Addendum No. 02

File Reference Number: RFP 2025 075

Title: Upgrade of RIP Track and Adjacent Facilities

RE: Clarifications/Questions

DWG. No. H375313-1000-220-270-0001

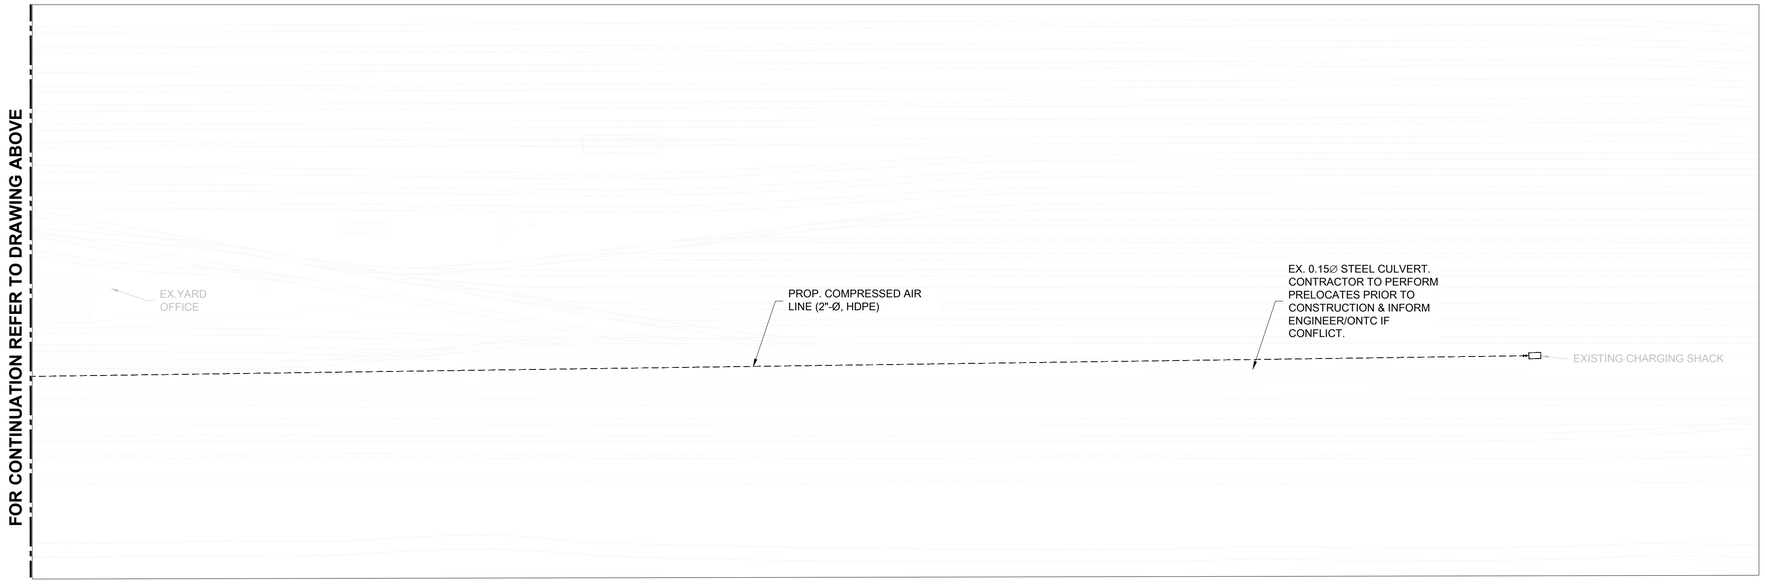
e) On civil drawing H375313-1000-220-270-0001, it shows the new sanitary line being install 0.72 meters off the wheelhouse foundation. Using the invert elevation off civil drawing H375313-1000-220-271-0005, including the bedding off 150 mm of clear stone and 100mm of A gravel, the bottom of excavation will be 2.54 meters below existing grade. Will this cause issues undermining the Wheelhouse Foundation?

Answer: Please be advised that ONTC has released the Issued for Tender (IFT) Drawings. These drawings have been listed and attached at the end of this Addendum. For responses to all of the questions listed above, respondents are requested to refer to and review the IFT Drawings.

A BURIED SERVICES TRENCHING
SCALE: 1:250

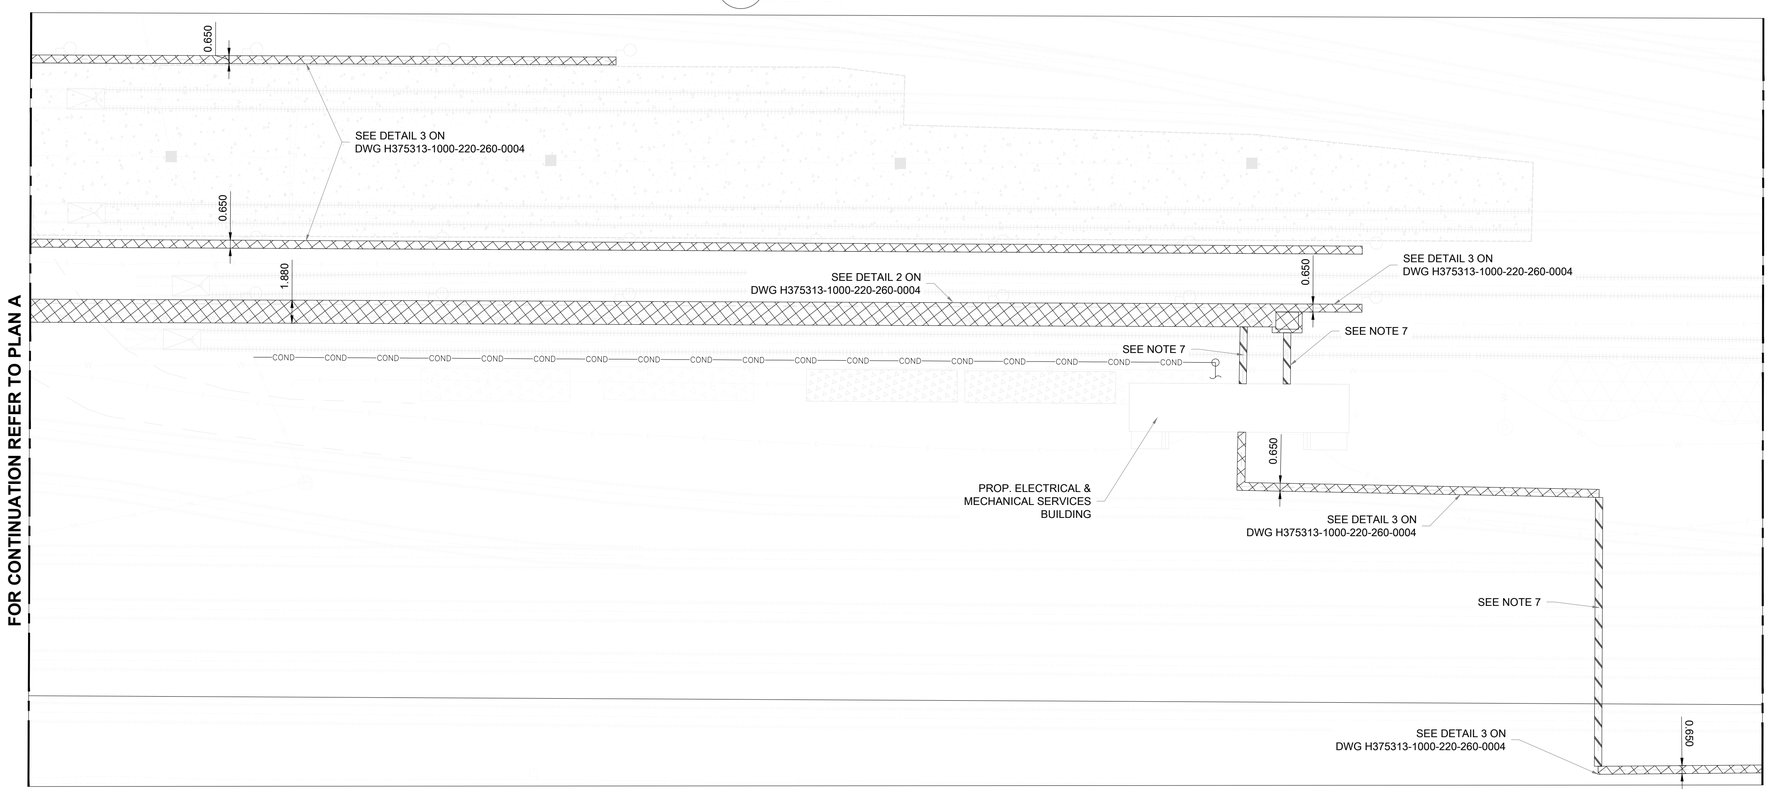
g) Civil & Drainage Buried Services Trenching Plan 1 shows alignment and width of trench. The width shown for the Sanitary Sewer adjacent to the Wheel shop has a shown width of 0.95 m. This width will not accommodate personnel or trench box required to place the pipe at shown depths.
